# COMPLETE MONOGRAPH

2015 GROUP A PUBLIC COMMENT AGENDA

SEPTEMBER 30 – OCTOBER 5, 2015  
LONG BEACH CONVENTION CENTER  
LONG BEACH, CA

Figure 1.

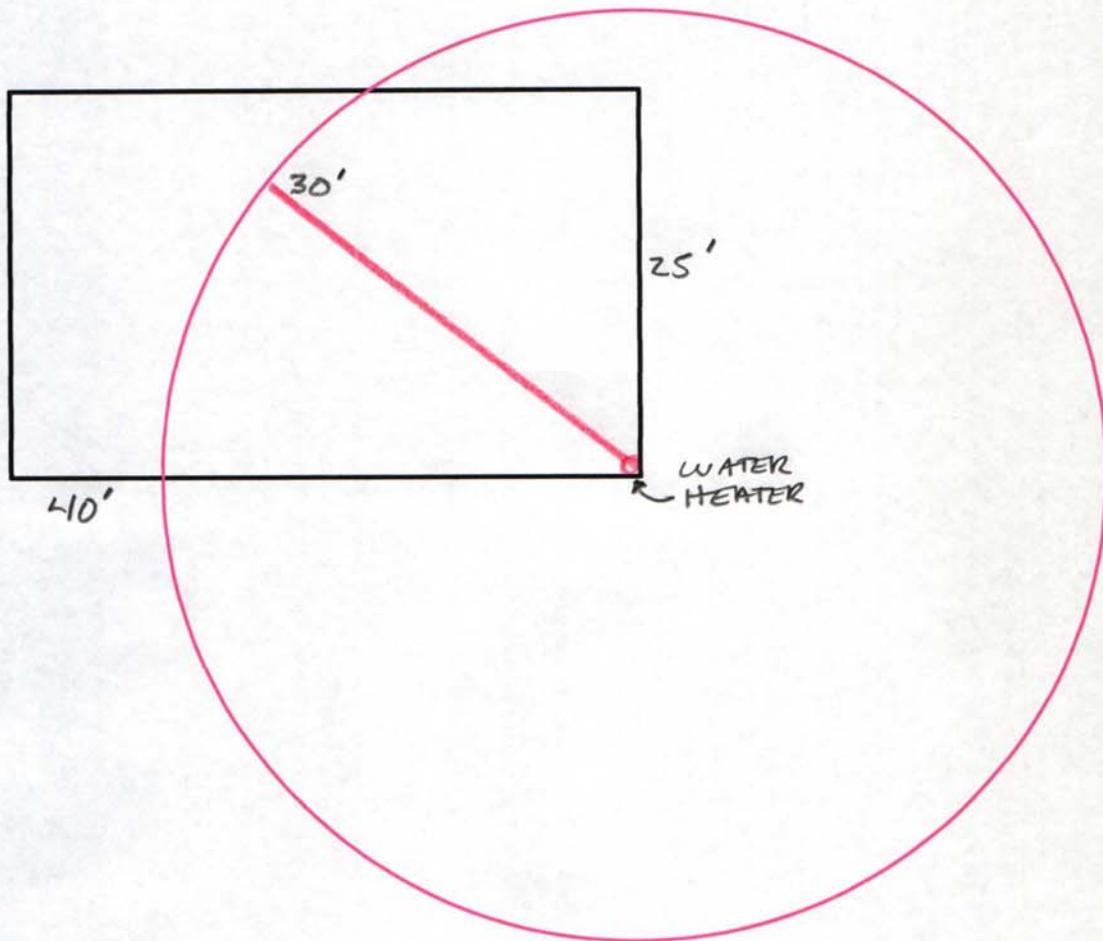
The following illustrations offer a demonstration of the simplicity of applying this proposal in practice. **Figure 1** is the most basic schematic of a very small single-story home of 1,000 square feet. As per the values in the proposed table, the straight-line distance allowed between the water heater and the outlet of a hot water fixture is 30 feet. In this example, the water heater is positioned in the corner of this house plan. If all hot water fixtures are within the 30' arc, the plan is compliant. However, if the outlet of a hot water fixture listed in the first paragraph of the proposal is located outside the 30' arc, the plan does not comply.

Figure 2.  
1000 S.F.  
1 STORY  
30 FT RADIAL ALLOWANCE  
ALL PLUMBING FIXTURES IN DWELLING COMPLY

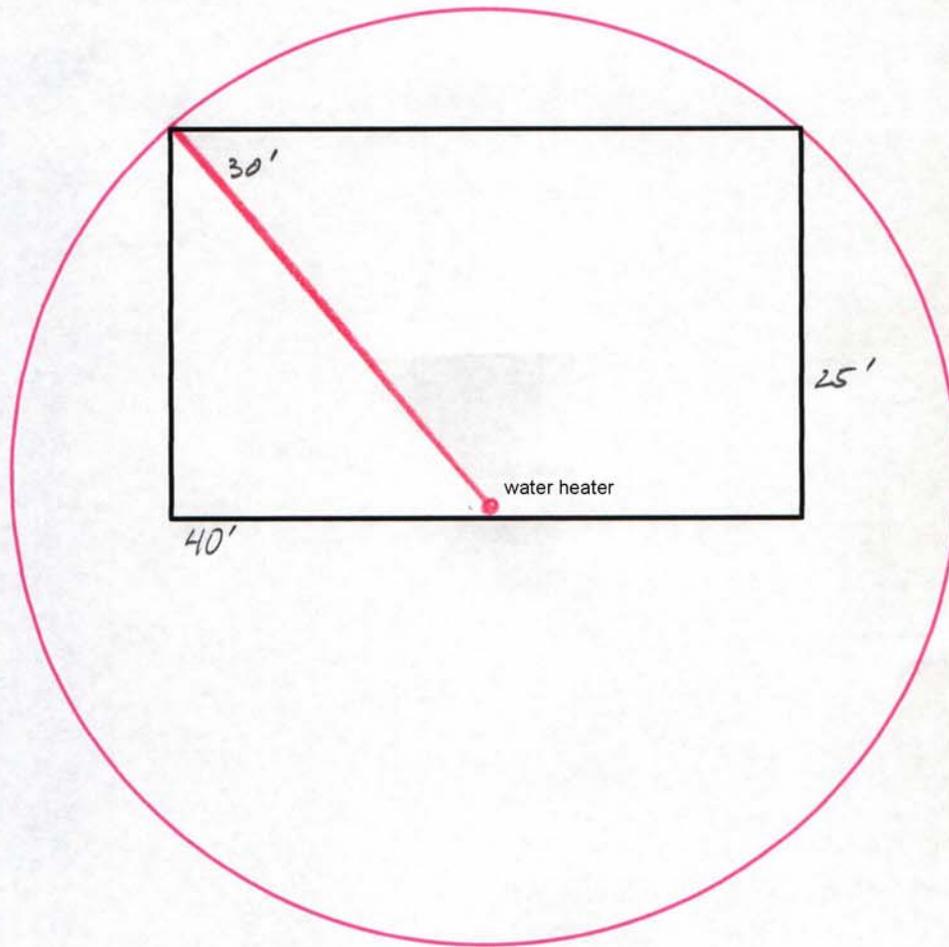
A second illustration of the same sized small home shows the effect of moving the hot water heater to a more central location. In **Figure 2**, the position of the hot water heater is at a more central point along an exterior wall. This entire home falls within the 30' arc, and the plan would be compliant for all possible locations of the hot water outlets within this home.

Figure 3.

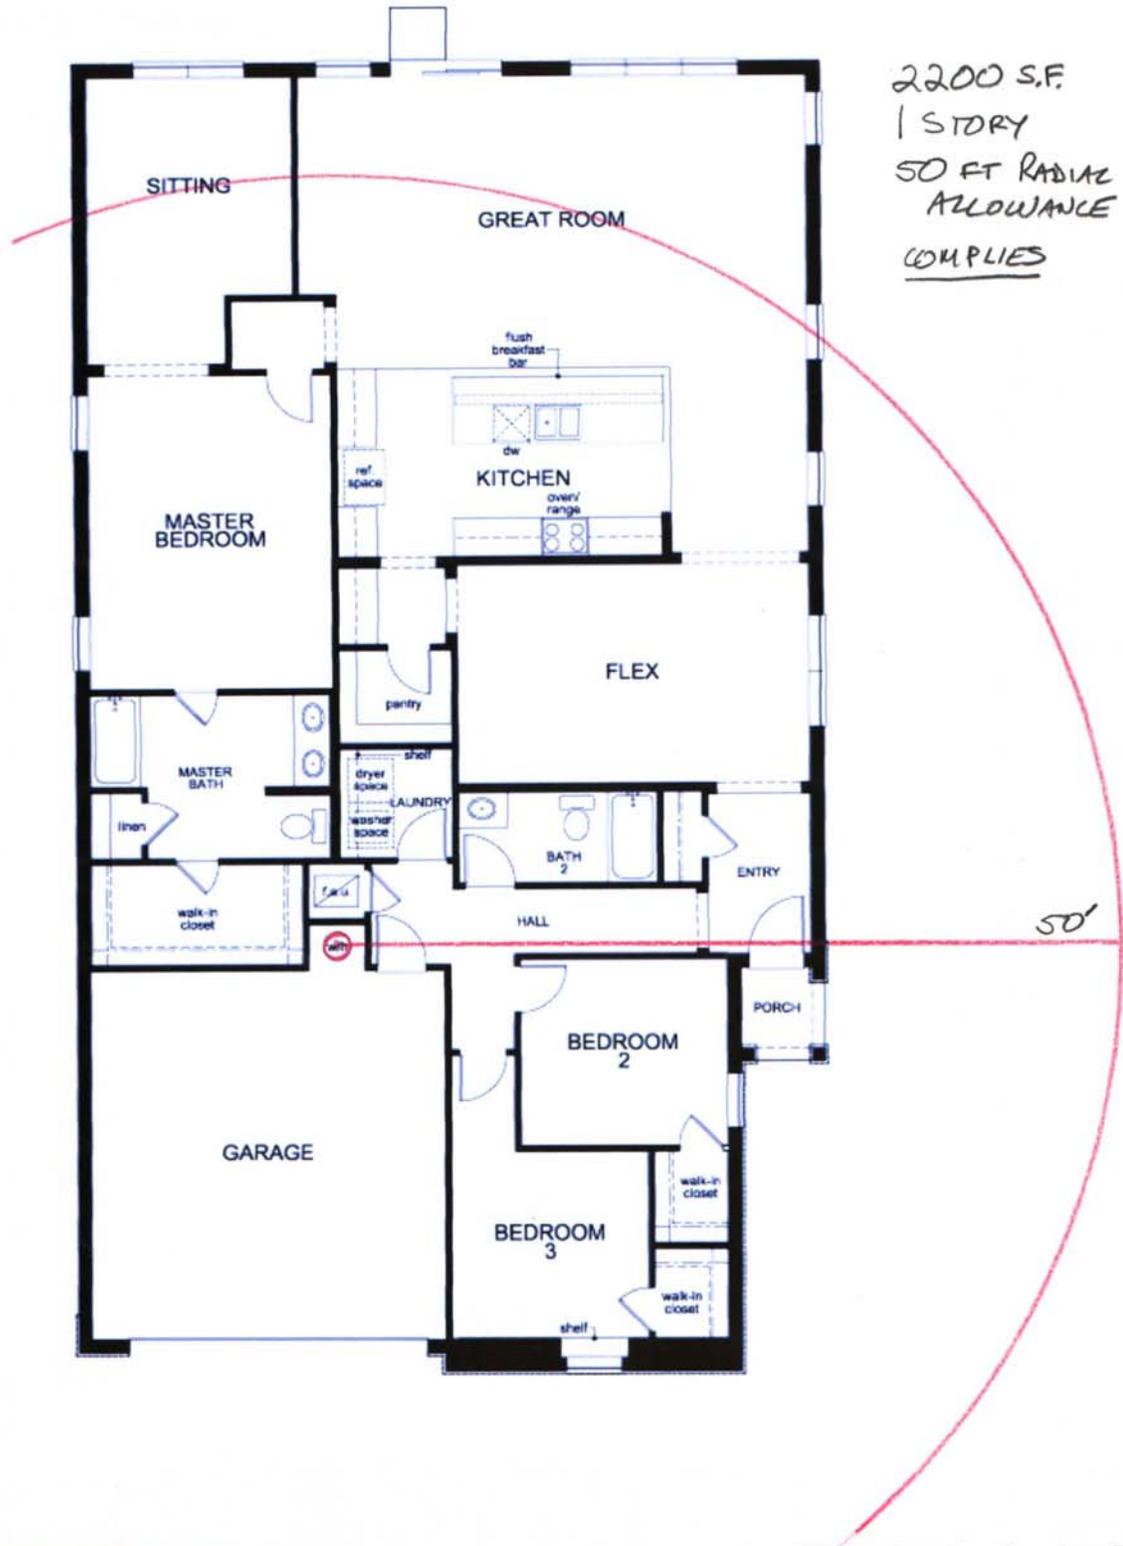
A third illustration shows the plan for a somewhat larger one-story home, with 2,200 square feet. In **Figure 3**, as per the values in the proposed table, the straight-line distance allowed between the water heater and the outlet of a hot water fixture listed in the first paragraph of the proposal is 50 feet. Here, all hot water outlets fall within the 50' arc, so the plan complies. Note, however, that *if* the master bath had been placed in the location of the sitting room, it is possible that one or more hot water outlets would have fallen outside the 50' arc, and such a plan would not comply. But some adjustment of fixture locations within the master bath by the designer would likely have brought the design into compliance.

**FIGURE 1**

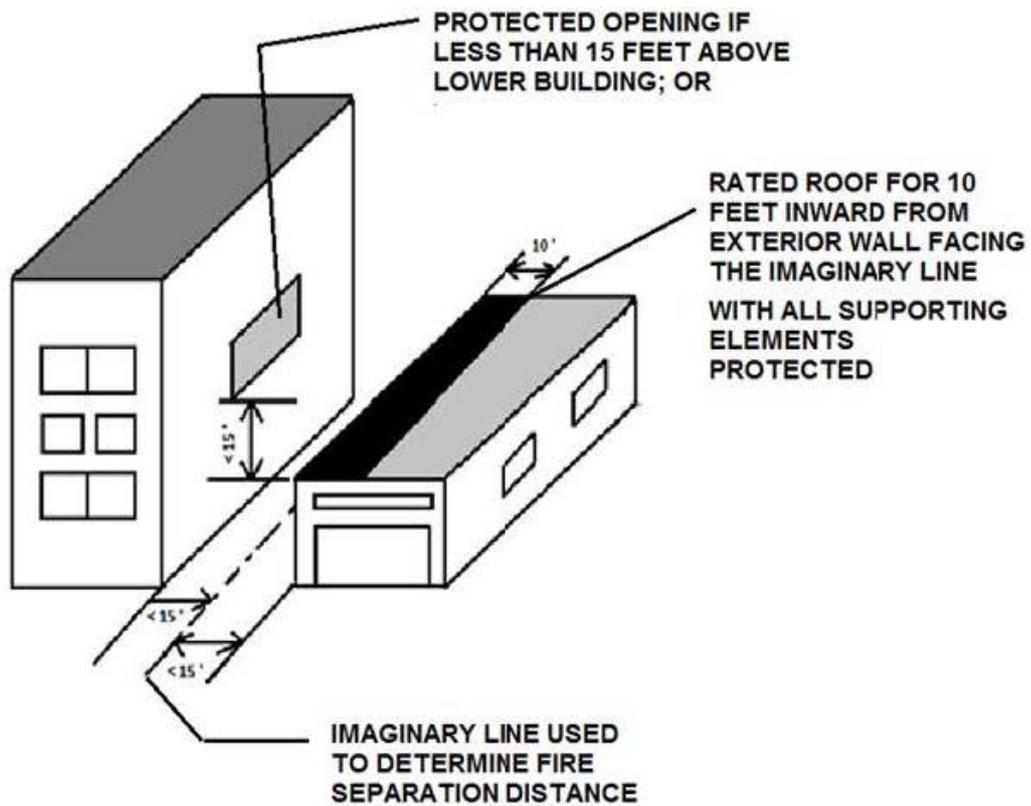
**Reason:** When applying this section to buildings on the same lot with an imaginary line designed to determine fire separation distance, it adds additional requirements that are not required in an identical situation with a real property line between buildings and with the same identical physical arrangement. It makes absolutely no sense to apply different and more stringent requirements to two identical scenarios. Both scenarios, an imaginary line and a real property line, have identical requirements of Table 602 for fire resistance based on fire separation distance, Table 705.2 for projections, Section 705.5 for exterior walls based on fire separation distance, Section 705.8 for exterior wall openings, Section 705.8.4 for mixed openings and Table 705.8 for exterior wall openings based on fire separation distance. Then we arrive at Section 705.8.6, for vertical exposure. This is the section that creates the conflict between imaginary lines and real property lines.

**FIGURE 2**

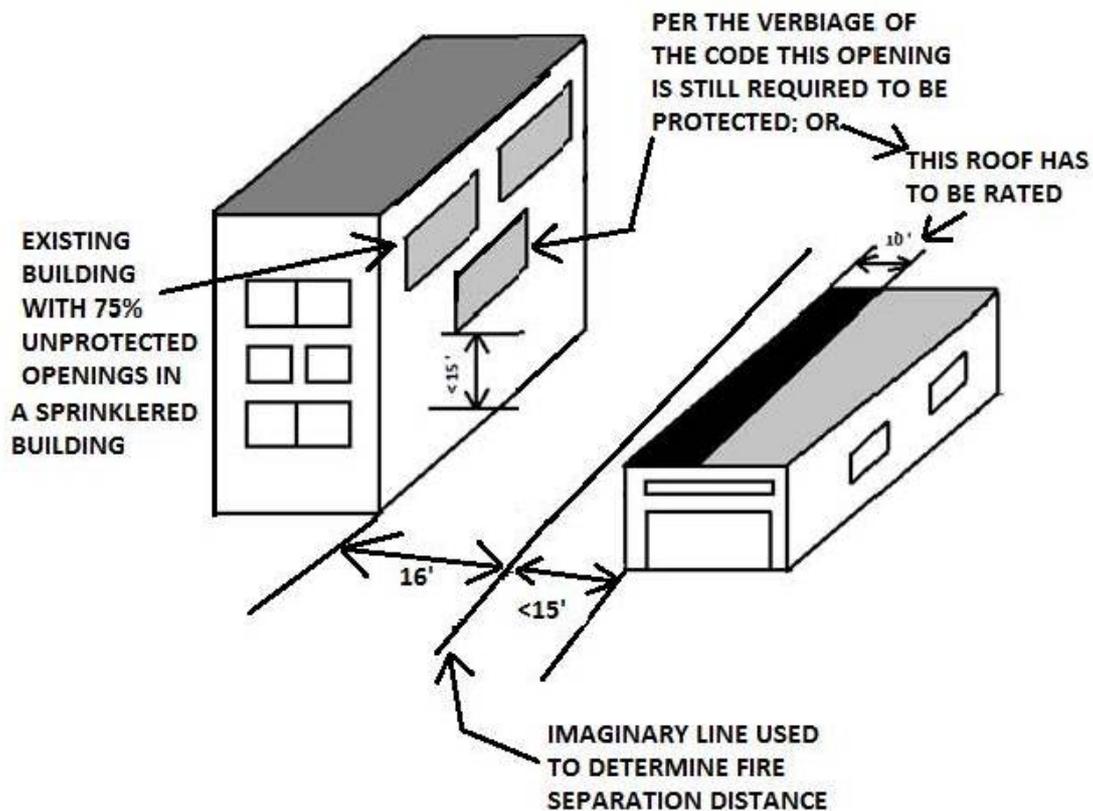
that "the current requirements presume that the imaginary line is equidistant between the two buildings" the code does not say that. It only refers to the adjacent (shorter building) having a fire separation distance if less than 15 feet. It also says "the provisions of Section 705.8.6 are intended to be applied where the adjacent exterior walls of both buildings are required by Table 602 to be fire-resistive rated." Again, the code does not say that it only applies if the lower building has a fire separation distance of less than 15 feet. One could have an existing building that had up to 75% of openings in the exterior wall,

**FIGURE 3**

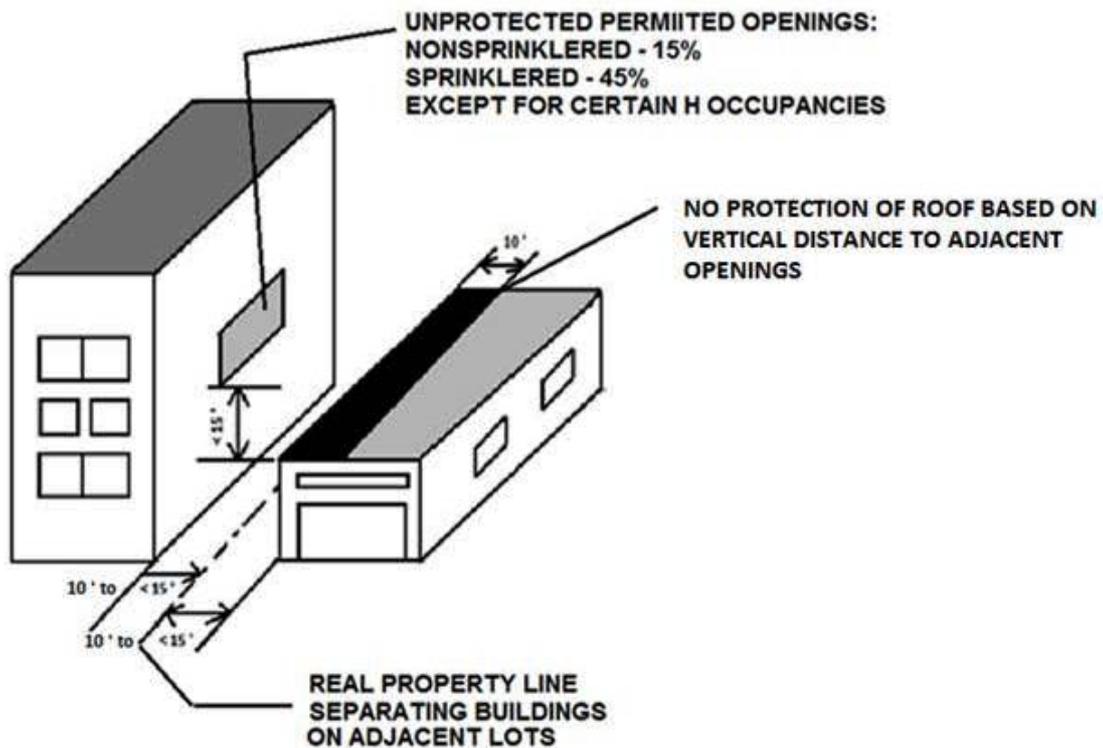
and another building was proposed to be constructed on the same lot 30 feet from it, one could place the imaginary line so the proposed building had a 14 foot fire separation distance and the taller one with the openings had a 16 foot fire separation distance the openings could remain unprotected in a non sprinklered building. But because of the code language, any opening that was less than 15 feet vertically above the adjacent roof would still be required to be protected because of the provision of measuring the fire separation distance for the lower building. Infact, you could have a much larger fire separation distance for the taller building but if the lower one was less than 15 feet, you would still have to protect to openings within the 15 foot range due to the absence of any fire separation distance for the building with the openings. Replacing the imaginary line with an actual property line,

**NOT ACCEPTABLE**

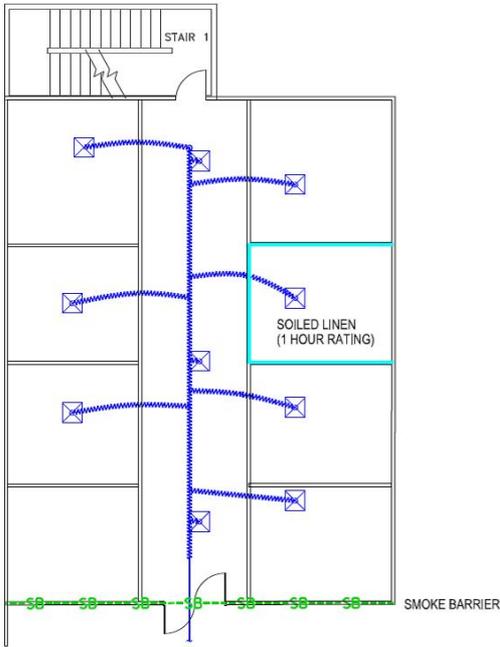
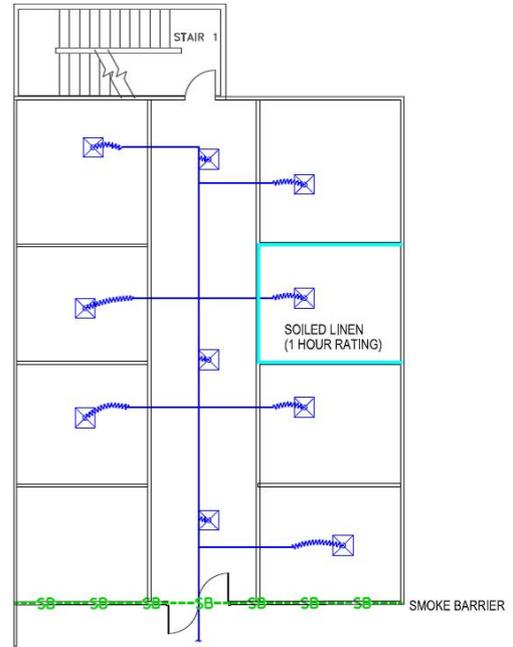
It is not the intention of the code change to allow flexible ducts through any vertical barriers. The flexible ductwork is only to be allowed within a room, and above the ceiling. See the sketch below to better clarify the intention.

# FS 142-15 Figure C Proposed Code Change

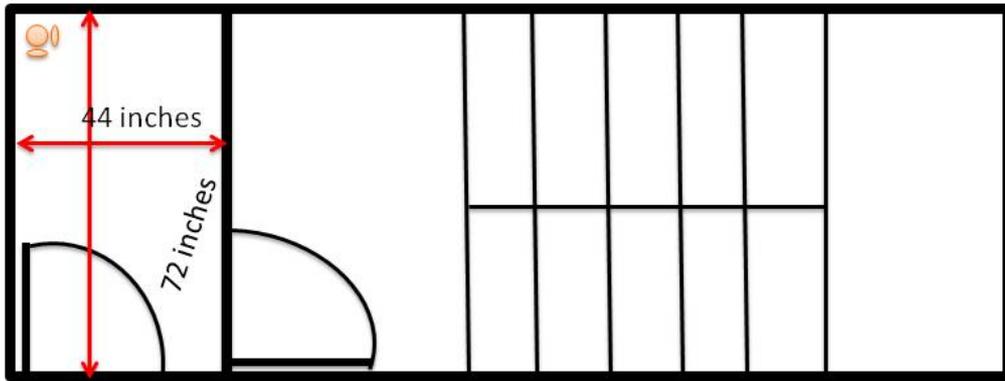
reviewing the IBC and ANSI A117.1 Chapter 4 it appears accessible route implies wheelchair access to something and unless there is a refuge area in a stairway an accessible route is not required. Figure C to Section 402.5 requires the door width plus 48 inches which exceeds 72 inches, and as a result it is not apparent that the 72 inch dimension intended by the IBC or legacy codes in editions that preceded accessible means of egress intended for the vestibule to be accessible. This issue is not addressed in the code change.
